Addendum No. 1
June 15, 2018

THE VILLAGE OF LAKE IN THE HILLS

VILLAGE HALL COUNTER REHAB
HR GREEN Job No. 171851

DRAWING
A10.2

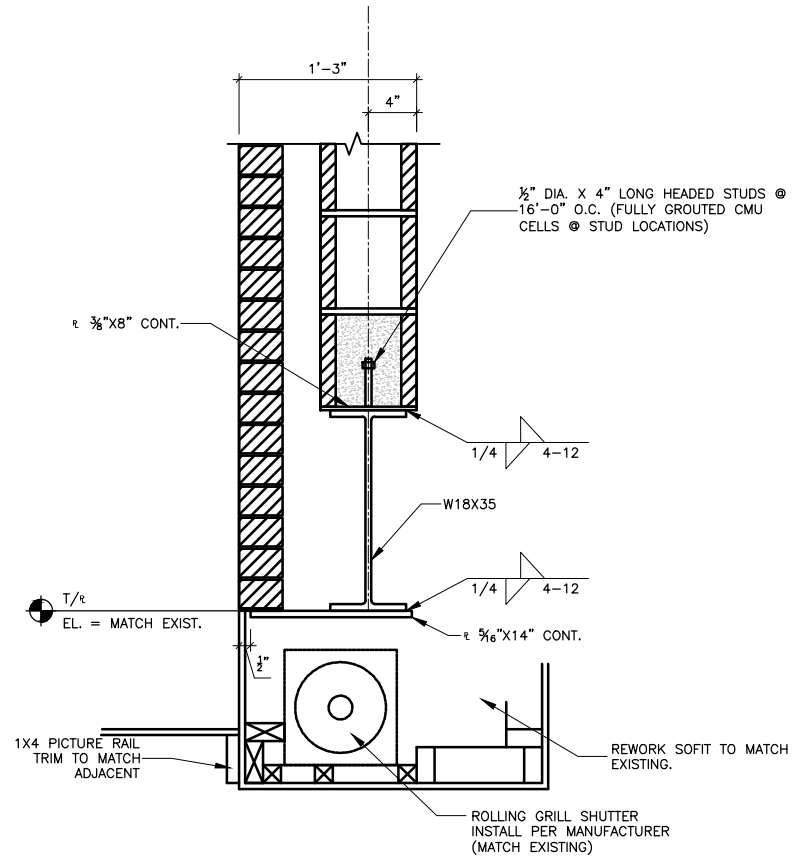
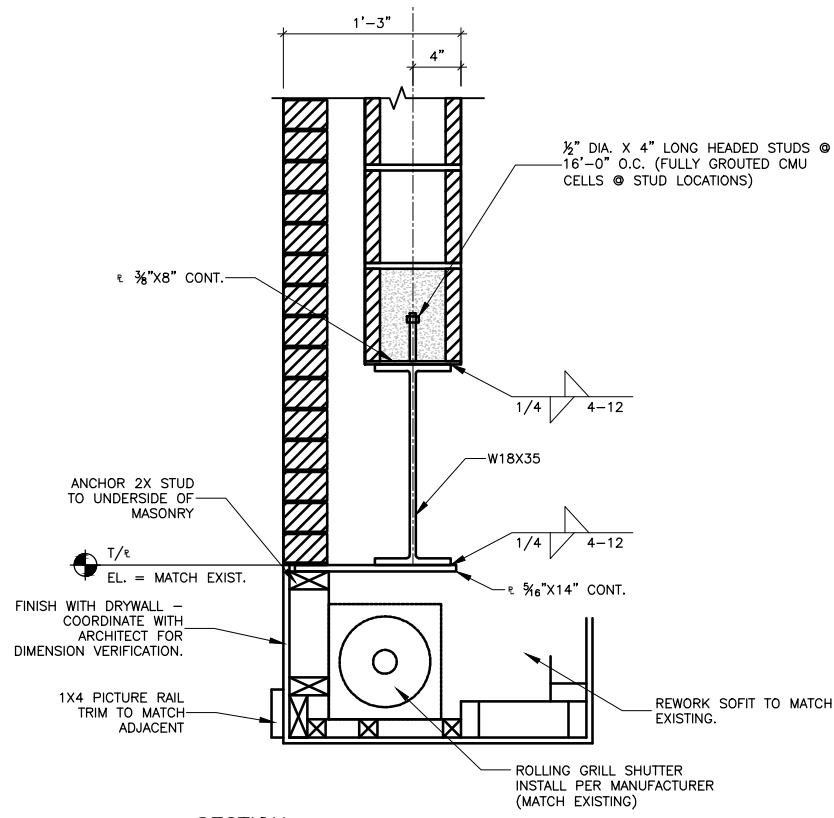
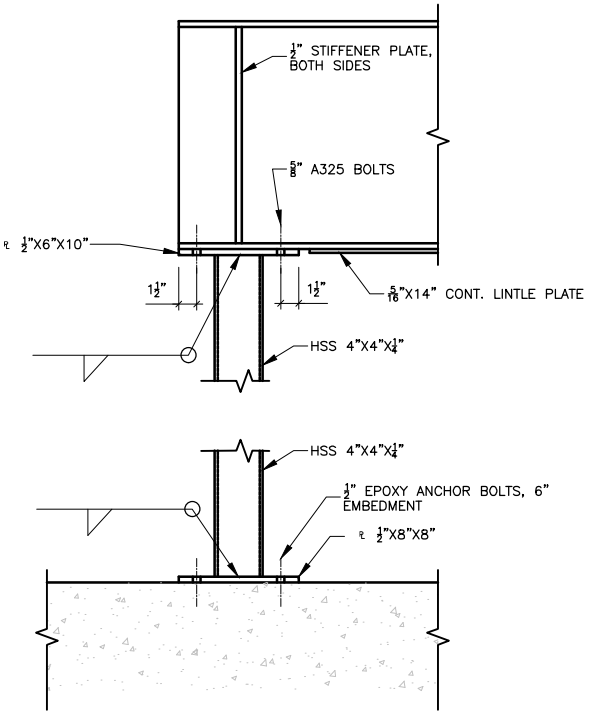
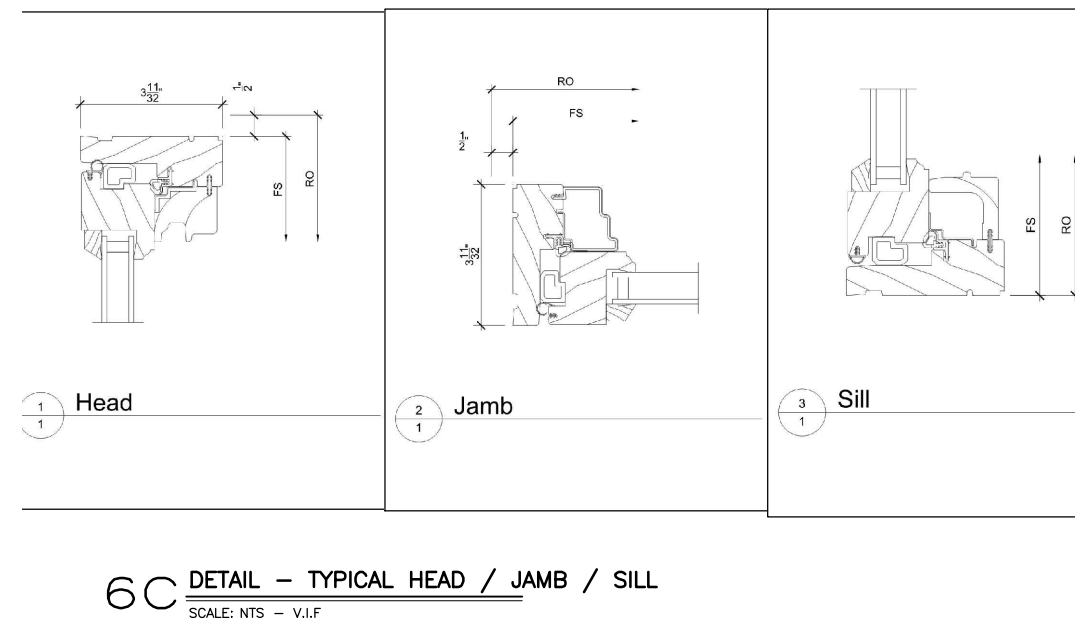
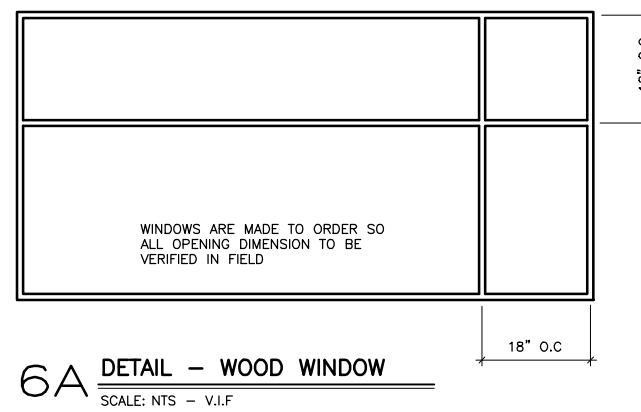
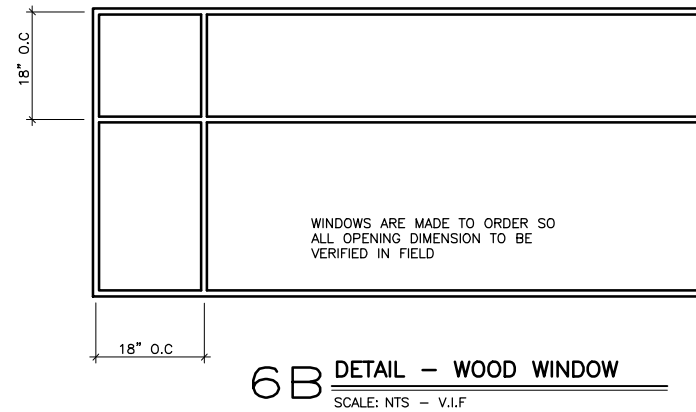
As a result of the pre-bid meeting, drawings A10.1 and A10.2 have been revised with additional notes and details, and drawing A10.3 has been added. Please refer to the drawings for final details. The drawings are attached and considered a part of the addendum.

1382778 A

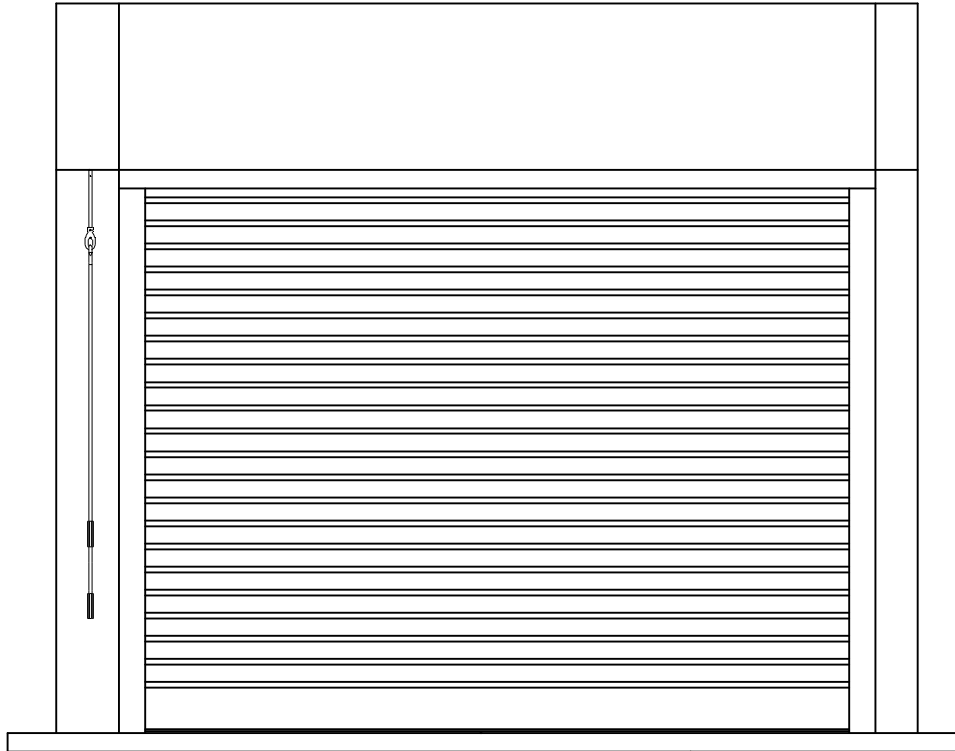
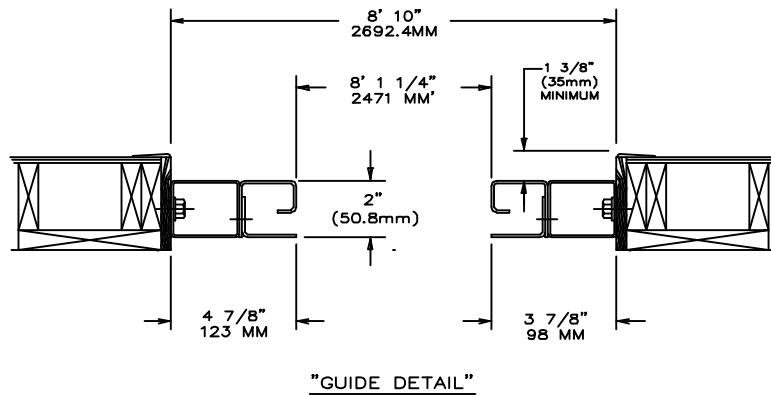
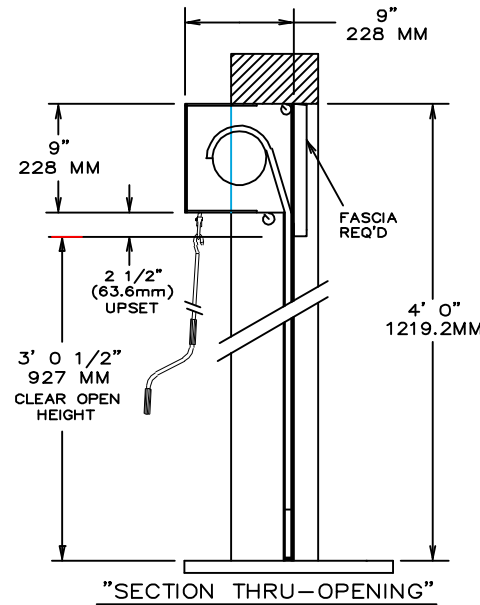
The manufacturer of the existing doors is Cookson Rolling Doors, Gastonia, North Carolina. Raynor Door Auth. of Rockford, LLC. is an acceptable alternative. Any design needed to use an alternative is the responsibility of he contractor.
